# Illustrated Parts List - IPL Update

**H440e II**

1. Oil hose

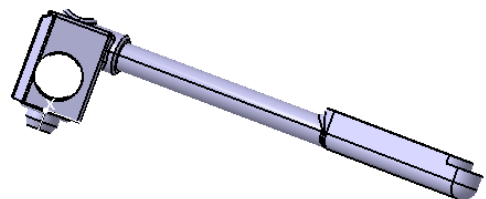
1. Updated Oil Hose 544 08 42-02 added. Sealing knob removed to simplify assembly.
